Project	IEEE 802.16 Broadband Wireless Access Working Group < <a href="http://ieee802.org/16">http://ieee802.org/16</a> >	
Title	<b>Text proposal for <del>MAC</del> handover <del>cases</del> procedure in an MR Network</b>	
Date Submitted	2006-11-16	
Source(s)	<p>Hyunjeong Lee <a href="mailto:hyunjeong.hannah.lee@intel.com">hyunjeong.hannah.lee@intel.com</a>  Wendy C. Wong  Jerry Sydir  Kerstin Johnsson  Intel Corporation</p> <p>Hyunjeong Kang <a href="mailto:hyunjeong.kang@samsung.com">hyunjeong.kang@samsung.com</a>  Hyoung Kyu Lim  Rakesh Taori  Samsung Electronics</p> <p>Kenji Saito <a href="mailto:saito@kddilabs.jp">saito@kddilabs.jp</a>  KDDI R&amp;D Lab Inc.</p> <p>Gang Shen <a href="mailto:gang.a.shen@alcatel-sbell.com.cn">gang.a.shen@alcatel-sbell.com.cn</a>  Kaibin Zhang  Alcatel, Research &amp; Innovation</p>	<p>Sujean Yang <a href="mailto:sujean35@ewhain.net">sujean35@ewhain.net</a>  Meejeong Lee <a href="mailto:lmj@ewha.ac.kr">lmj@ewha.ac.kr</a>  Dept. of Computer Science and Engineering  Ewha Womans University</p> <p>Yousuf Saifullah <a href="mailto:yousuf.Saifullah@nokia.com">yousuf.Saifullah@nokia.com</a>  Shashikant Maheshwari  Haihong Zheng  Nokia</p> <p>Sungkyung K

**Figure 1 Seven Handover Cases in an MR network**

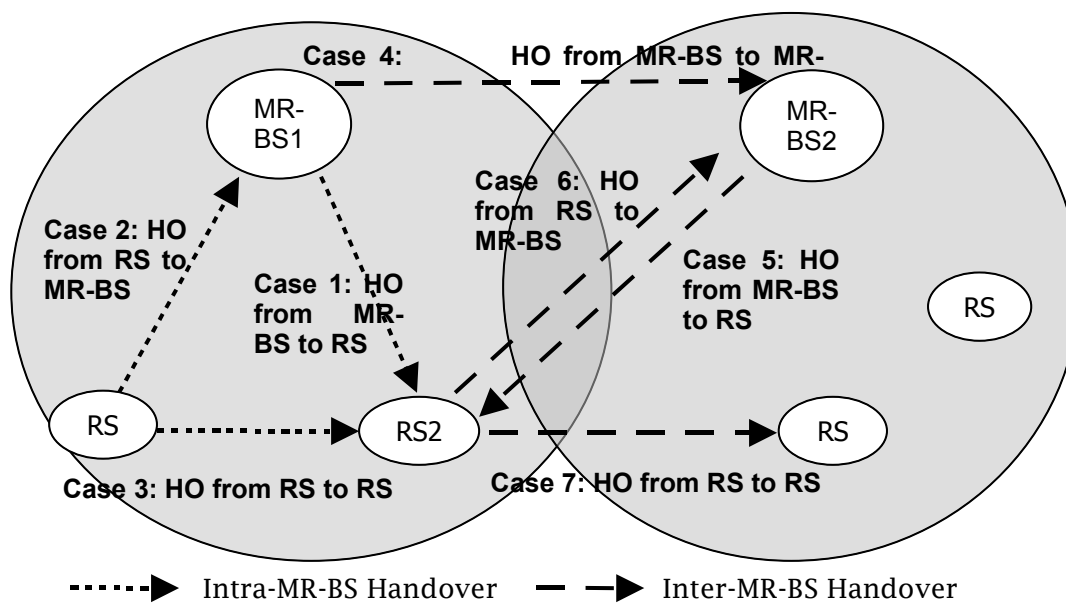
Due to the introduction of RSs into the network infrastructure, seven different handover cases illustrated in can occur in an MR network. The seven cases belong to two main categories of handover: (1) Intra MR-BS handover if the handover is between two RSs controlled by the same MR-BS or between an MR-BS and one of its subordinate RSs; and (2) Inter MR-BS handover if the handover is between two MR-BSs, two RSs each controlled by different MR-BSs, or between an MR-BS and an RS controlled by a different MR-BS.

~~All~~The six new cases (i.e., Cases 1, 2, 3, 5, 6, and 7) require signaling among involved RSs and MR-BSs to support handover. ~~Therefore, this subclause also~~ contains procedures for infrastructure stations to support MS handover if the MS is attached to an MR network.

The hHandover procedures for these cases shall accommodate various types of RSs of different capabilities depending on the functional split between MR-BS and its subordinate RSs.
